KEYSTONE XL PIPELINE PROJECT

0543-SD-P4-XXX.X-XXX.X-S

KEYSTONE XL PIPELINE PROJECT PIPELINE ROUTE VARIATION FORM			
1	VARIATION TYPE:	Refinement: <input type="text"/>	Reroute: <input type="text"/>
		Centerline: <input checked="" type="checkbox"/>	Pump Station: <input type="text"/>
		Footprint: <input checked="" type="checkbox"/>	Design: <input checked="" type="checkbox"/>
		Valve Site: <input type="text"/>	CAR: <input type="text"/>
2	LOCATION:	Sketch: <input type="text" value="Attached"/>	Pictures: <input type="text" value="N/A"/>
	State: <input type="text" value="SD"/>	County: <input type="text" value="Various"/>	Quad Map: <input type="text" value="N/A"/>
	Township: <input type="text" value="Various"/>	Range: <input type="text" value="Various"/>	Aerial Map: <input type="text" value="See attached map sheet"/>
	Section: <input type="text" value="Various"/>	Centerline: <input type="text" value="6/11/2013"/>	MP: <input type="text" value="XXX.X"/> to <input type="text" value="XXX.X"/>

RV-0543-01 ROUTE REVISION

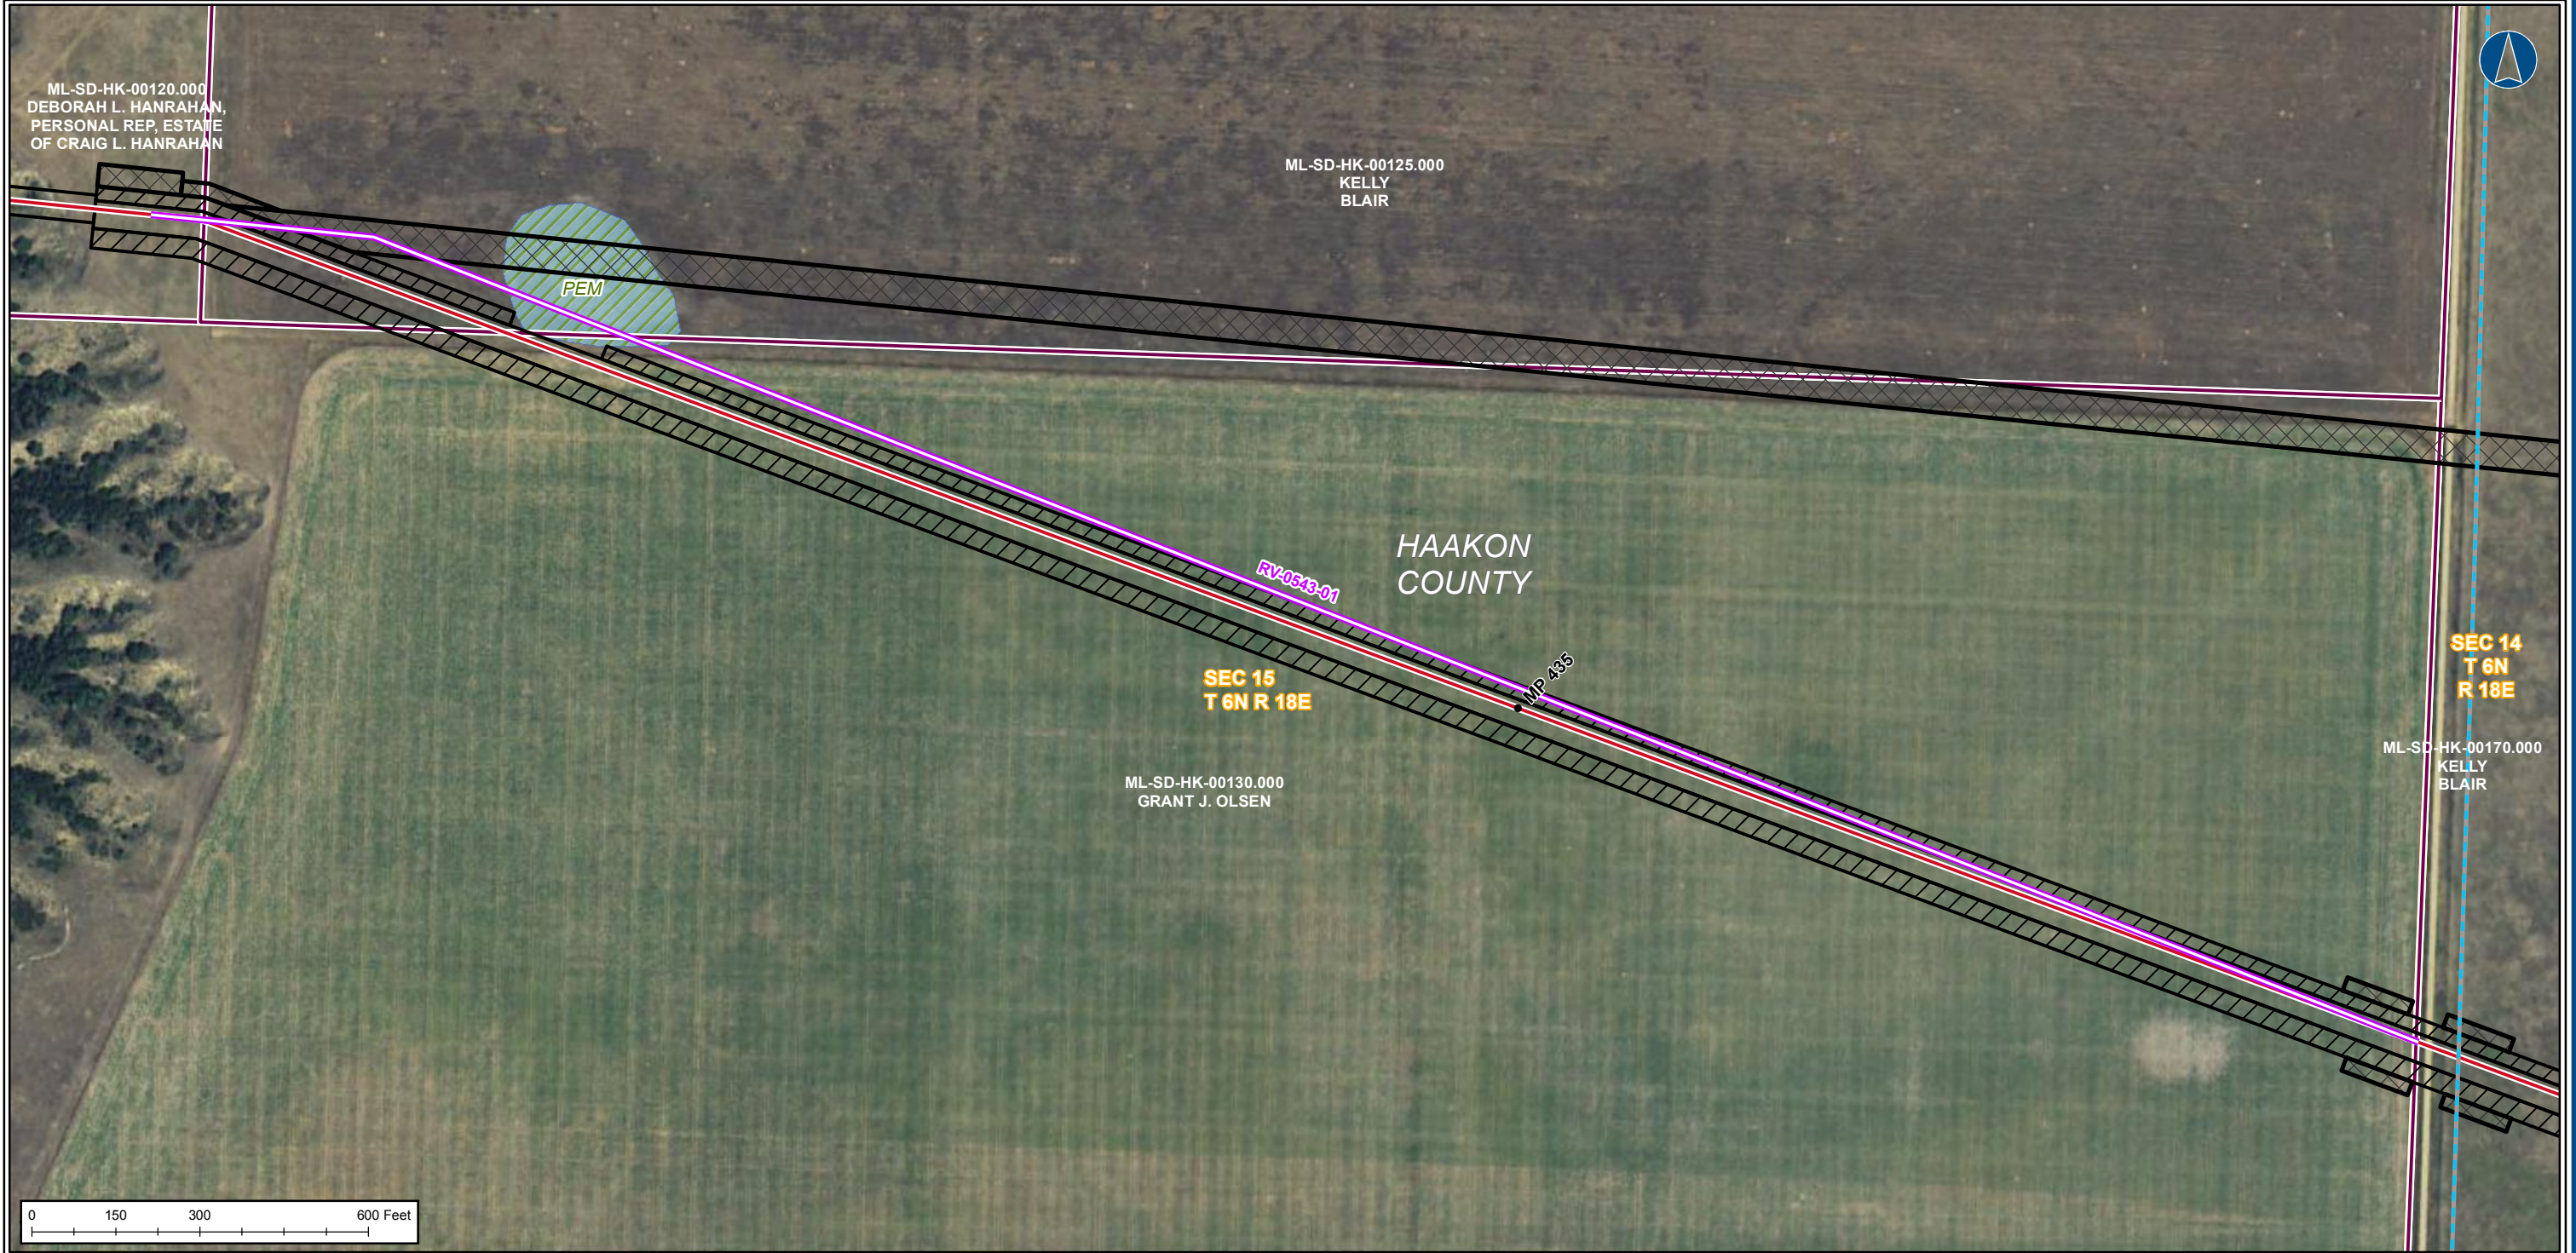
3	REASON FOR ROUTE VARIATION (Please include reason for route variation):		
	<p>The primary reason for this design change is to incorporate Keystone XL HDD design recommendations for three (3) HDD locations in South Dakota based on the Laney Directional Drilling Co. review.</p> <p>This review was conducted based on comments and design changes proposed by Michels Corporation and has been subsequently reviewed by Engineering.</p>		
	DETAIL ROUTE VARIATION (Please describe route variation in detail):		
	<p>1. Ash Creek Bluff HDD (MP 431.22)</p> <ul style="list-style-type: none"> - Extended HDD exit point by 100 ft downstream. This also increases the total horizontal distance from 3480 ft to 3580 ft and the HDD length from 3522 ft to 3635 ft. Existing workspace including pull back area will be adjusted by 100 ft as a result. - Adjusted HDD exit angle from 12° to 14°. - Depth of cover will be increased by 40 ft by lowering the bottom tangent elevation from 1856 ft to 1816 ft. <p><u>1 tract impacted:</u> ML-SD-HK-00020.000 (Craig & Deborah Hanrahan)</p> <p>2. Bridger Creek HDD (MP 433.59)</p> <ul style="list-style-type: none"> - Extended HDD exit point by 300 ft downstream and the entry point by 150 ft upstream. This also increases the total horizontal distance from 8335 ft to 8785 ft and the HDD length from 8443 ft to 8897 ft. - Centerline change will be required to accommodate the 300 ft extension at the exit point of the HDD (Please see map attached). Pull back area will be extended 300 ft. Neck down at Wetland crossing. - Depth of cover will be increased by 50 ft by lowering the bottom tangent elevation from 1875 ft to 1825 ft. <p><u>4 tracts impacted:</u></p> <ul style="list-style-type: none"> - ML-SD-HK-00120.000 (Deborah L. Hanrahan, Personal Rep, Estate of Craig L. Hanrahan) - ML-SD-HK-00125.000 (Kelly Blair) - ML-SD-HK-00130.000 (Grant J. Olsen) - ML-SD-HK-00170.000 (Kelly Blair) <p>3. Bad River HDD (MP 485.97)</p> <ul style="list-style-type: none"> - The only adjustment to be made will be a depth of cover increase of 20 ft by lowering the bottom tangent elevation from 1760 ft to 1740 ft. As a result, HDD length will also increase from 2062 ft to 2065 ft (3 ft increase). <p><u>0 tracts impacted:</u> No above ground impact.</p>

ADDITIONAL IMPACTS (Please include any additional impacts which may affect cost; crossings, induction bends, etc.):		
	<p>No additional costs associated with environmental surveys. Civil survey will be required for the Bridger Creek centerline change.</p> <p>For HDDs, 1 ft = ~ \$529. The following costs and distances are based on increases in HDD length. Ash Creek Bluff HDD = 113 ft x \$529 = ~ \$59,777 Bridger Creek HDD = 454 ft x \$529 = ~ \$240,166 Bad River HDD = 3 ft x \$529 = ~ \$1,587 Total = ~ \$301,530</p>		
	Is there an increase/decrease in the number of crossings?	Yes <input type="text"/>	No <input checked="" type="checkbox"/>
	If yes, please list:	<input type="text"/>	
	COST ANALYSIS (costs incurred or saved from the route variation)		
	Additional length of route realignment	11 ft.	\$ 3,960.00 \$ 360/ft
	Additional length of side-hill construction:	0 ft.	\$ - \$ 19/ft
	Additional length of wetland construction:	0 ft.	\$ - \$ 195/ft

Comments:	If Rejected Why?	
TransCanada - Environmental Sandra Barnett	Variation: Approved <input checked="" type="checkbox"/> Rejected <input type="checkbox"/>	Date: 1/13/14
Comments:	If Rejected Why? Work's pace needs to be kept out of the wetland.	
Stantec - Risk Assessment Heidi Tilquist	Variation: Approved <input type="checkbox"/> Rejected <input type="checkbox"/>	Date:
Comments:	If Rejected Why?	
TransCanada - Facilities Sandra Gigovic	Variation: Approved <input type="checkbox"/> Rejected <input type="checkbox"/>	Date:
Comments:	If Rejected Why?	
TransCanada - PM (Montana) Alan Lietz	Variation: Approved <input type="checkbox"/> Rejected <input type="checkbox"/>	Date:
Comments:	If Rejected Why?	
TransCanada - PM (South Dakota) James Odom	Variation: Approved <input checked="" type="checkbox"/> Rejected <input type="checkbox"/>	Date:
Comments:	If Rejected Why?	
TransCanada - PM (Nebraska) Robert Bradley	Variation: Approved <input type="checkbox"/> Rejected <input type="checkbox"/>	Date:
